SUBJECT: Approval of Amendment 02/97 (Municipal Golf Courses) to 1995
Forest Park Master Plan

AMENDMENT NO. 02/97

(MUNICIPAL GOLF COURSES)

Proposed Amendment No. 02117 Municipal Golf Courses
To The Forest Park Master Plan

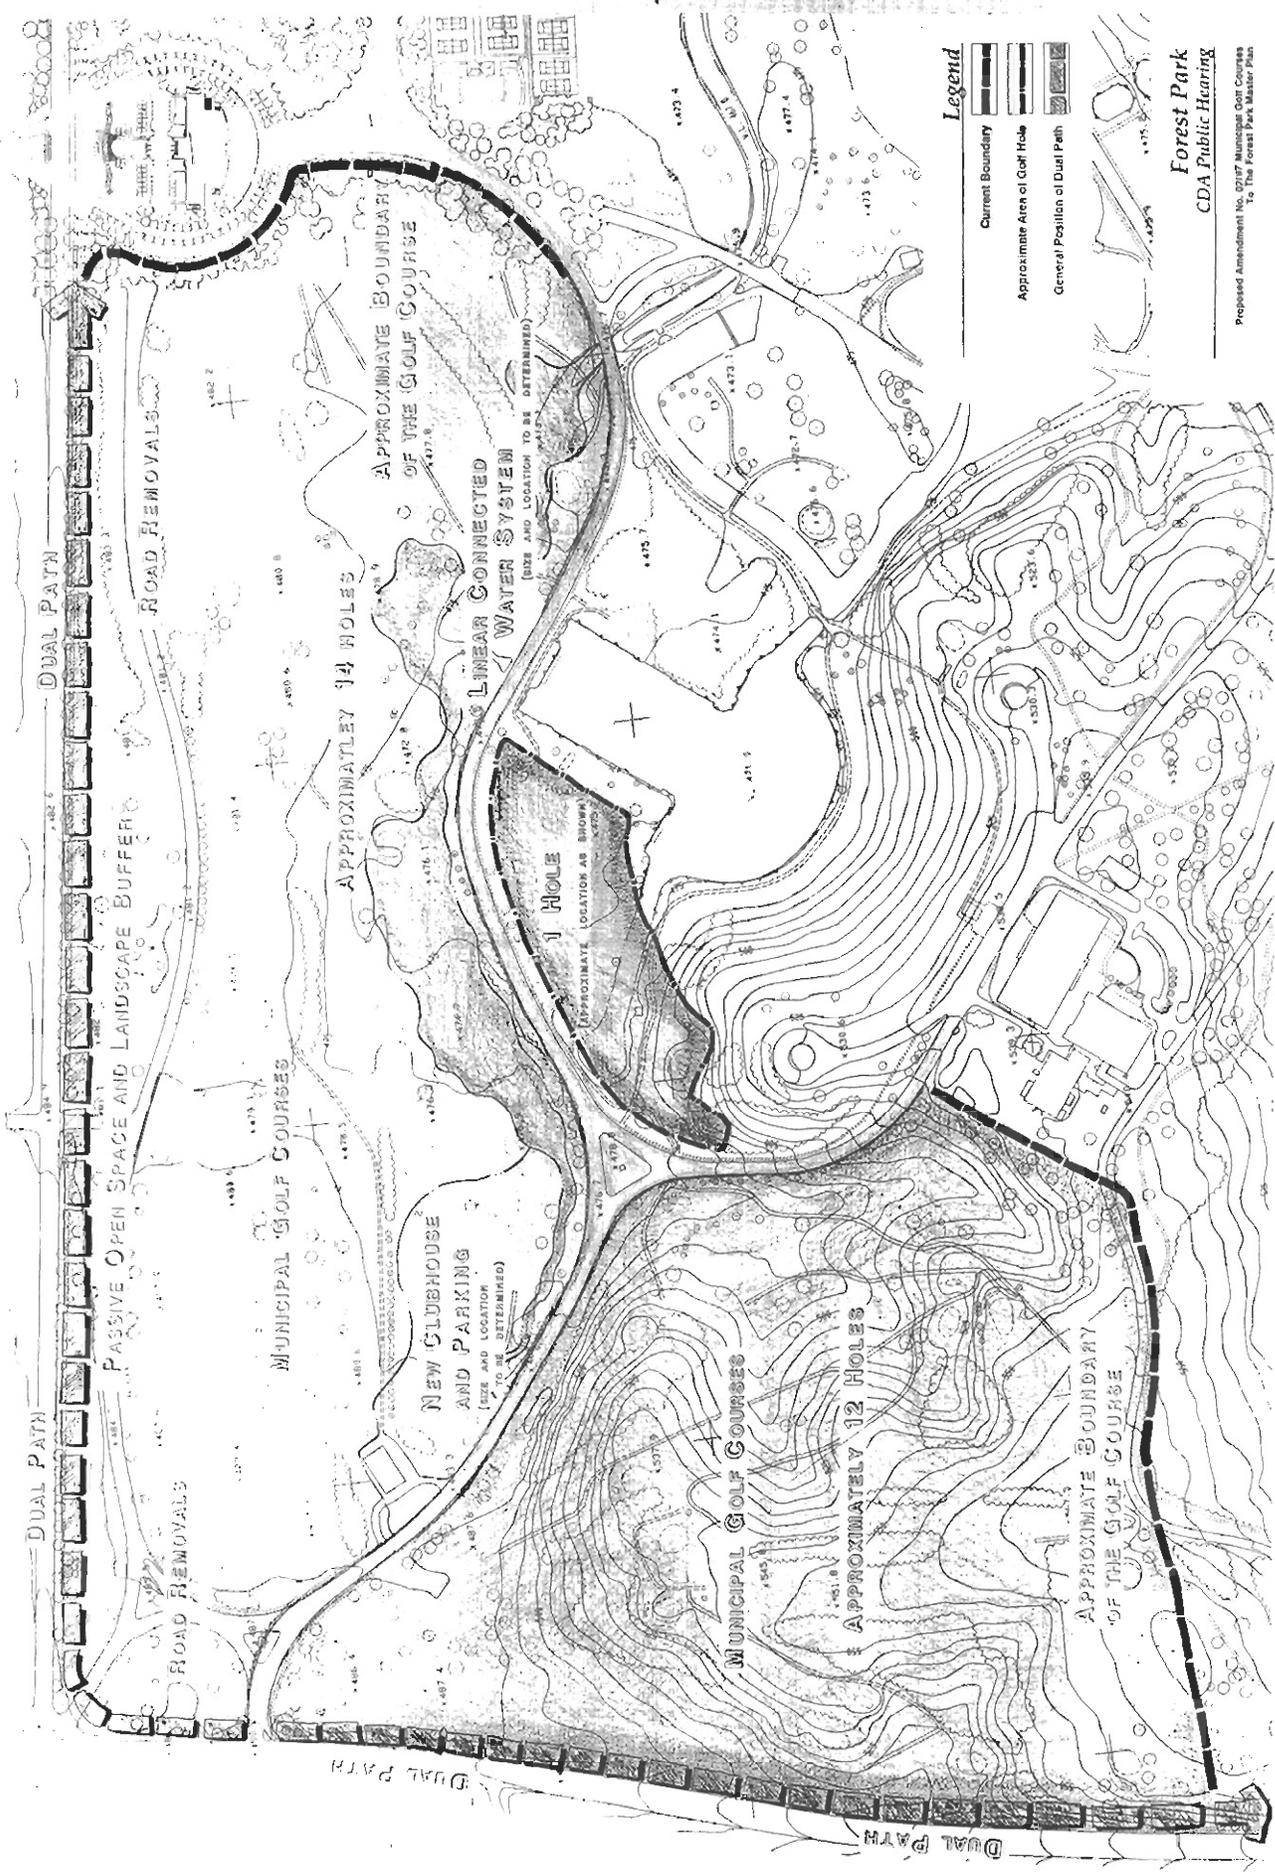
- a. Notwithstanding anything in the 1995 Forest Park Master Plan to the contrary, the Municipal Golf Courses will have 27 holes consisting of 3 returning nines, and golf course operations will be relocated to a new clubhouse building and a new parking lot.

- b. Notwithstanding anything in the 1995 Forest Park Master Plan to the contrary, existing hole 16, located on the western edge of the Art Hill/Grand Basin, is slightly modified in order to allow for the proposed promenade and walkway around Grand Basin, but remains approximately in its current location.

- c. Notwithstanding anything in the 1995 Forest Park Master Plan to the contrary, the proposed soft surface path from the Des Peres Ave./Lindell Blvd. intersection to the Grand Basin is deleted.

- Relocate *four* [five] golf holes away from the Art Hill/Grand Basin to create open space for passive recreation.
- Improve drainage and golf course quality with new lake system and wetlands. The water level will fluctuate within the lake/wetlands system and the water may be used for irrigation purposes.

- *The Municipal Golf Courses will have 27 holes consisting of 3 returning nines, and golf course operations will be relocated to a new clubhouse building and a new parking lot.* [Consider two golf course options: i) 27-hole course. ii) an 18-hole course.]
